TOWN OF FAIRFAX STAFF REPORT

то:	Planning Commission
DATE:	May 16, 2024
FROM:	Linda Neal, Principal Planner
LOCATION:	152 Dominga Avenue; APN # 002-023-10
ZONING:	RD 5.5-7 Zone, Residential, High Density
PROJECT:	Remodel and second story addition to an existing single-family residence
ACTION:	Conditional Use Permit, Design Review Permit and Floor Area Ratio Exception; Application # 24-06
APPLICANT:	Stewart Summers, Architect
OWNER:	Gary and Jessica Hanley
CEQA STATUS:	Categorically exempt, § 15301(e)(2)(a) and 15305(a)

152 DOMINGA AVENUE APN # 002-023-10

RESOLUTION NO. 2024-09

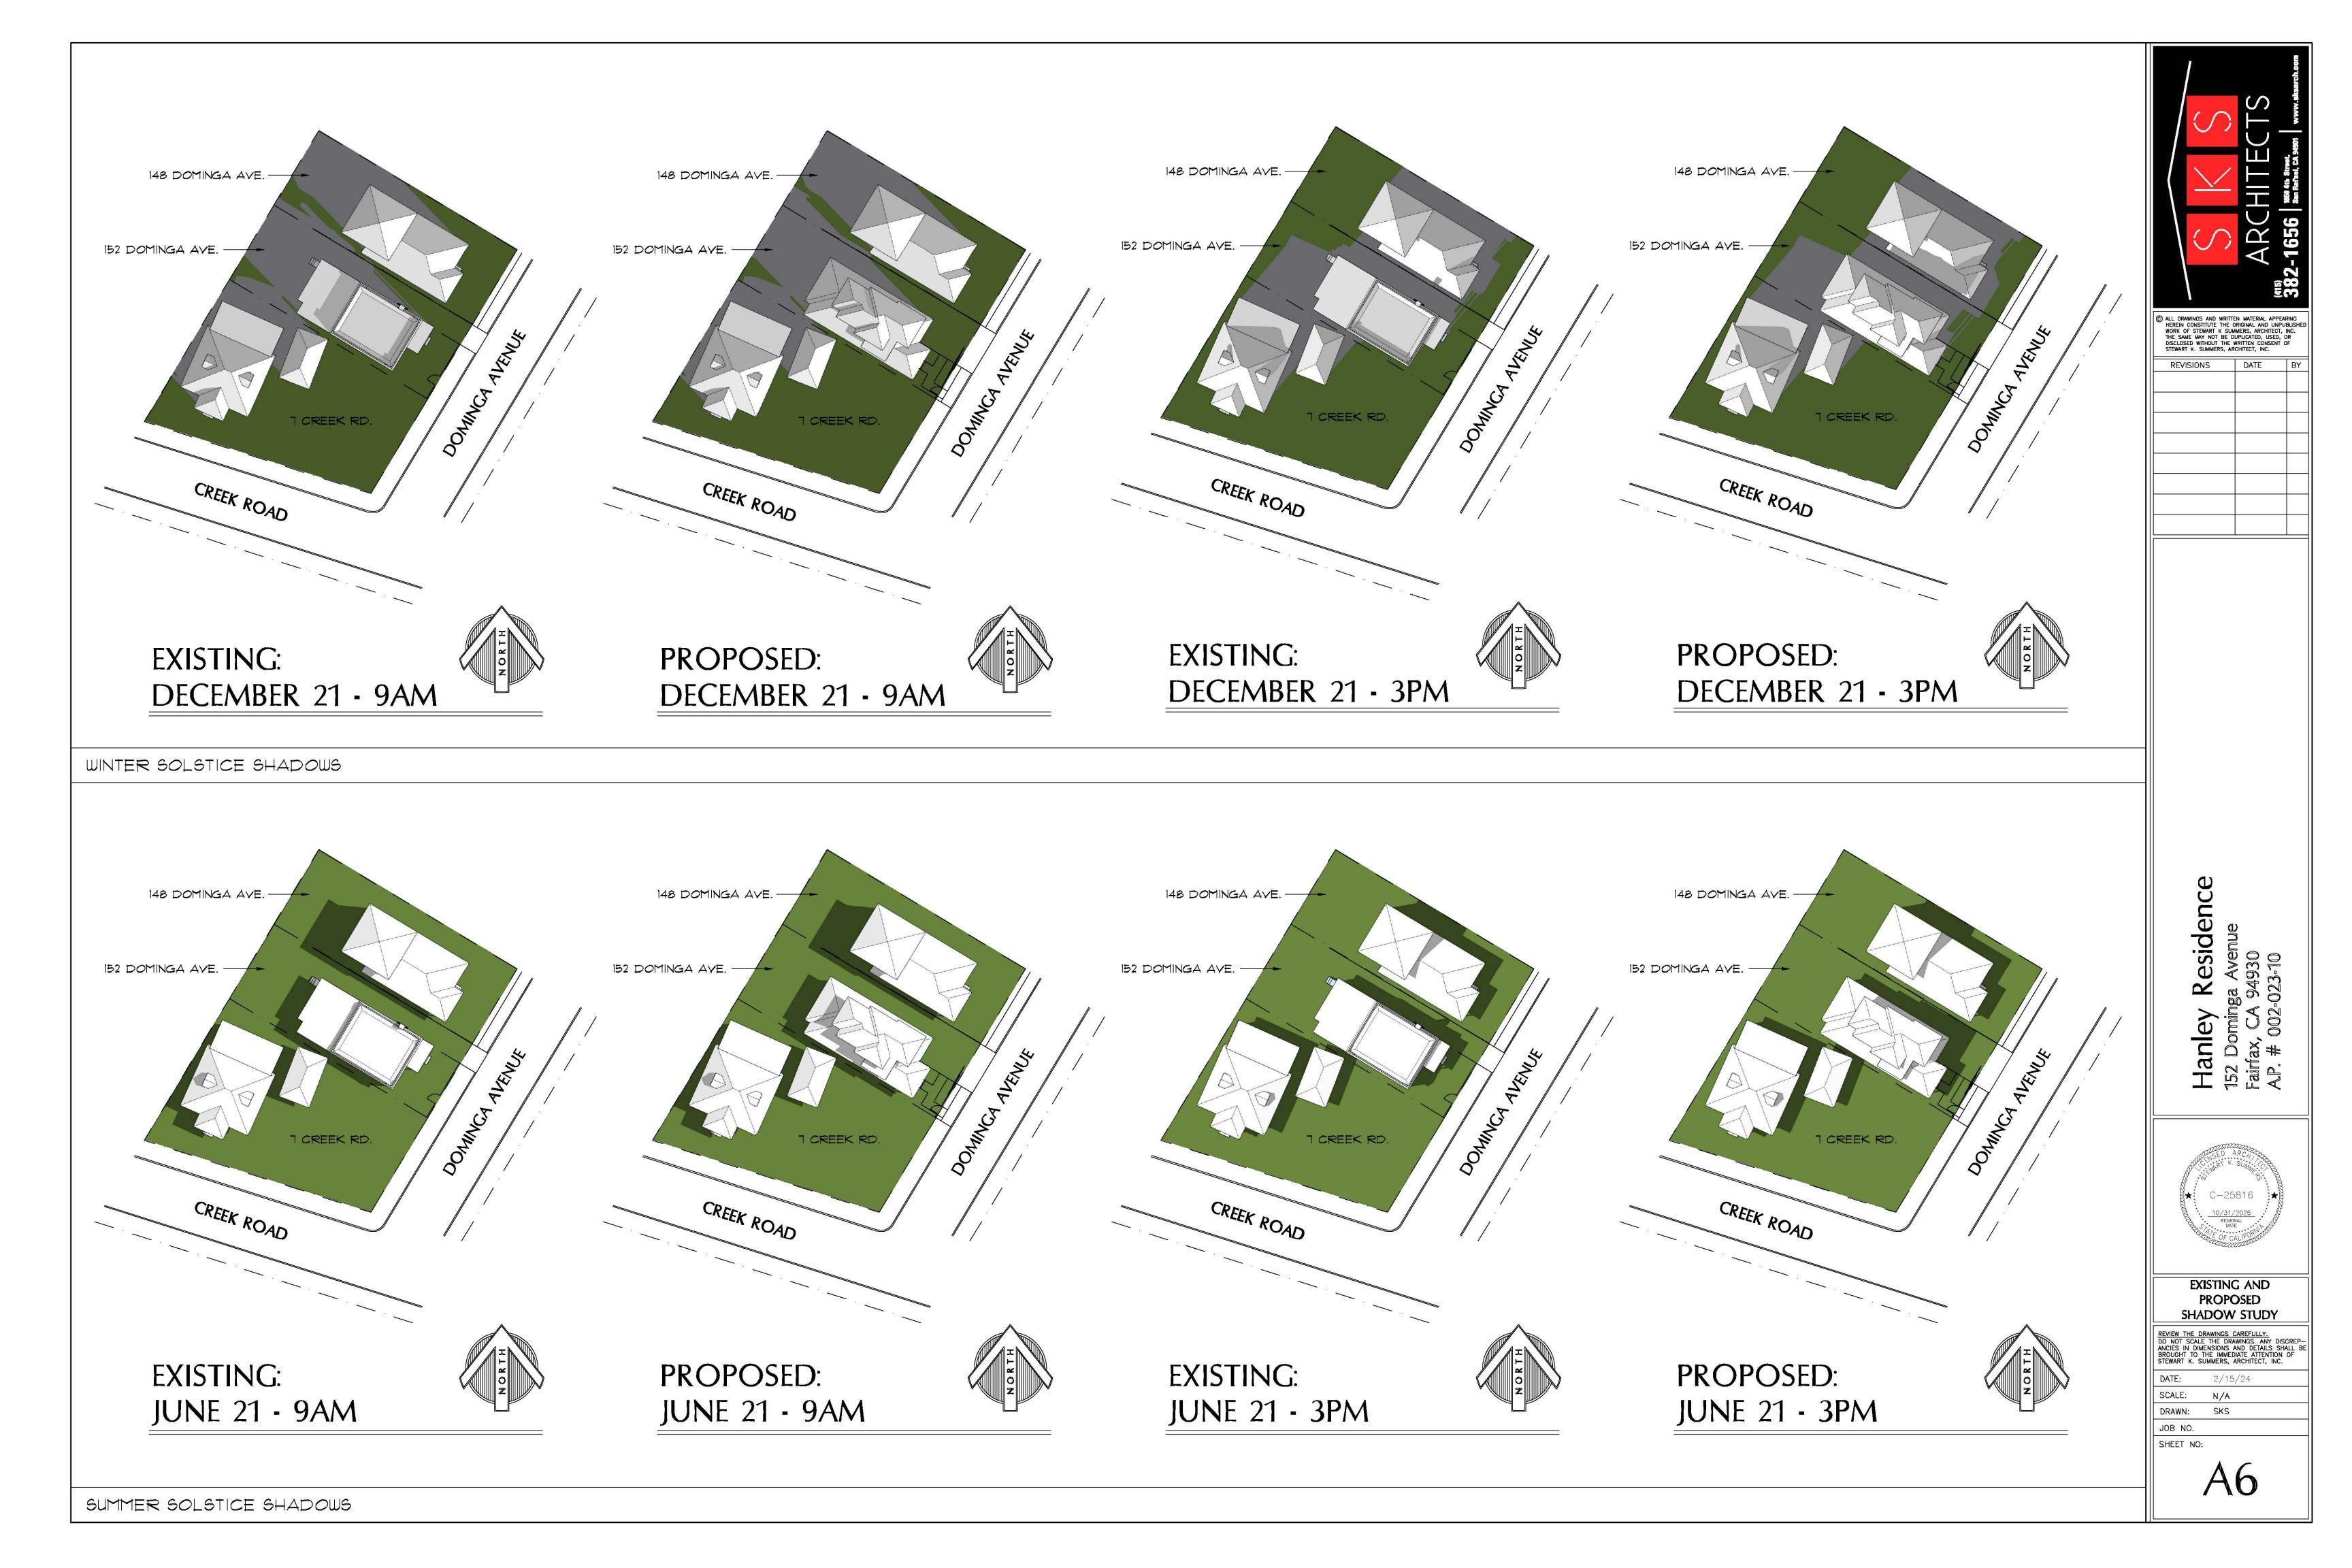
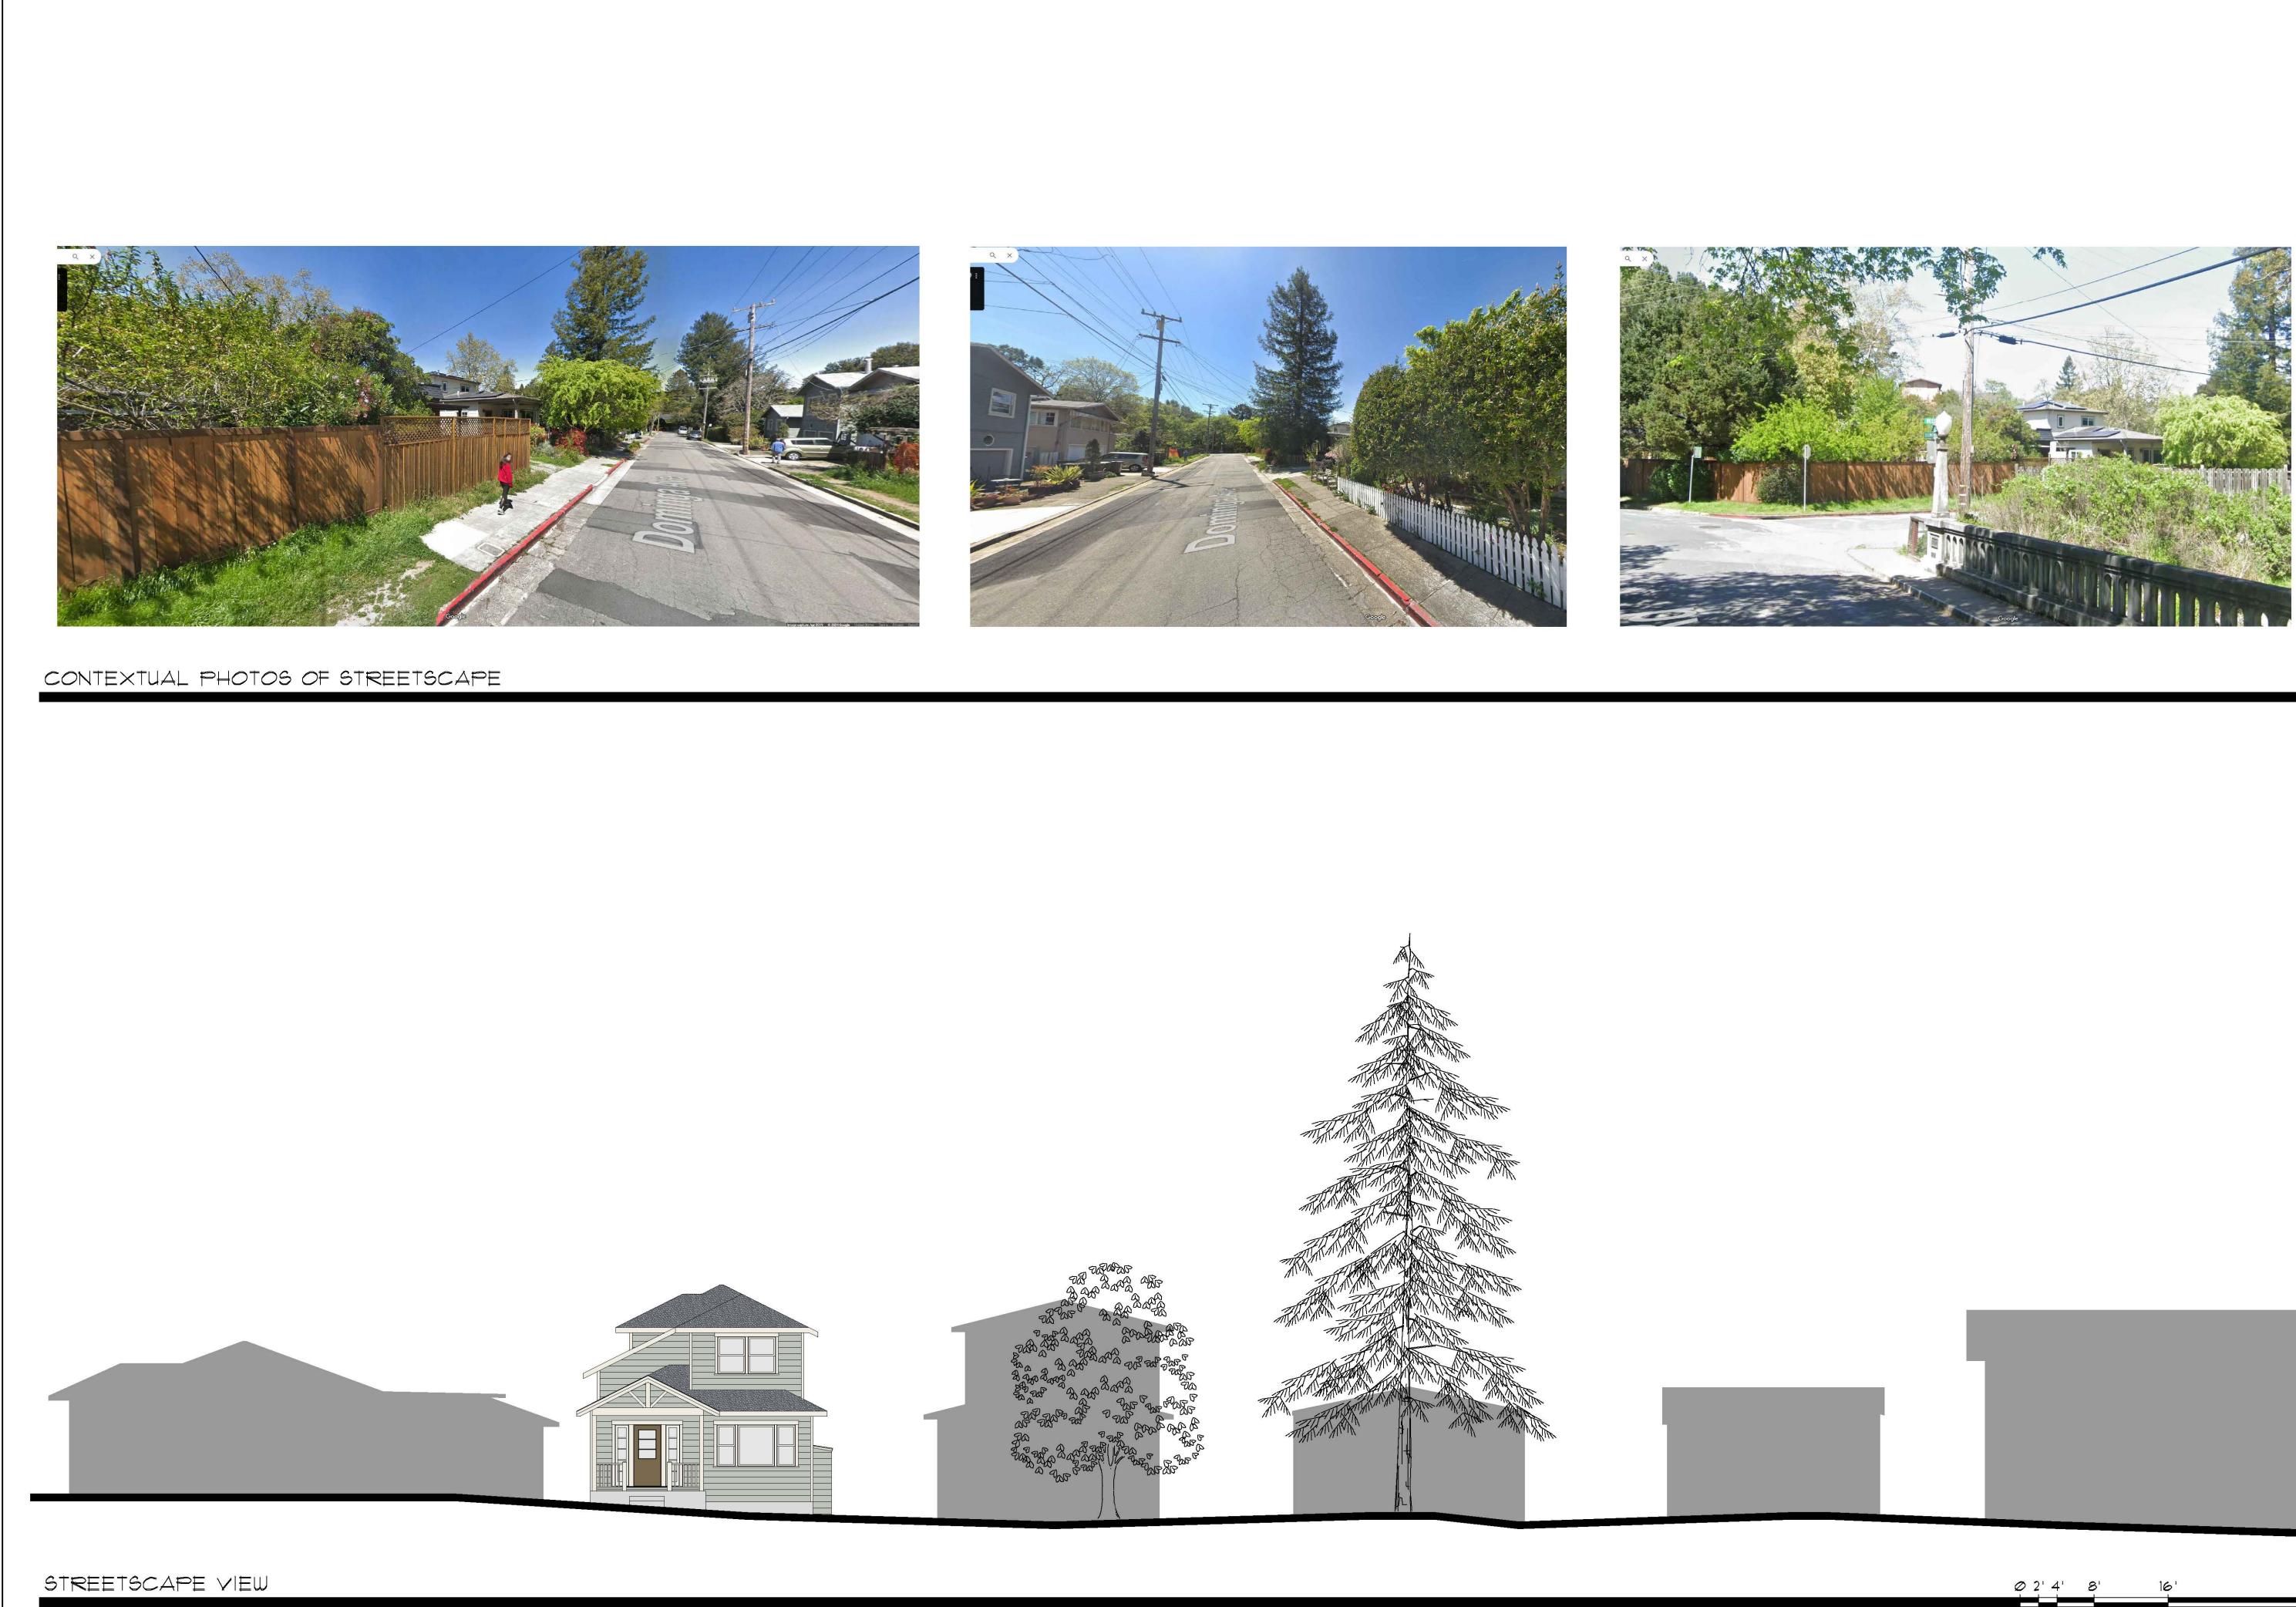
- 5. VMP not required as project is not located in the WUI
- 6. Contextual Photos have been added to sheet A7 to accompany the streetscape drawing.
- 7. Colored Rendering is located on new sheet A8. Photos of property and adjacent neighbors also added to sheet A8.
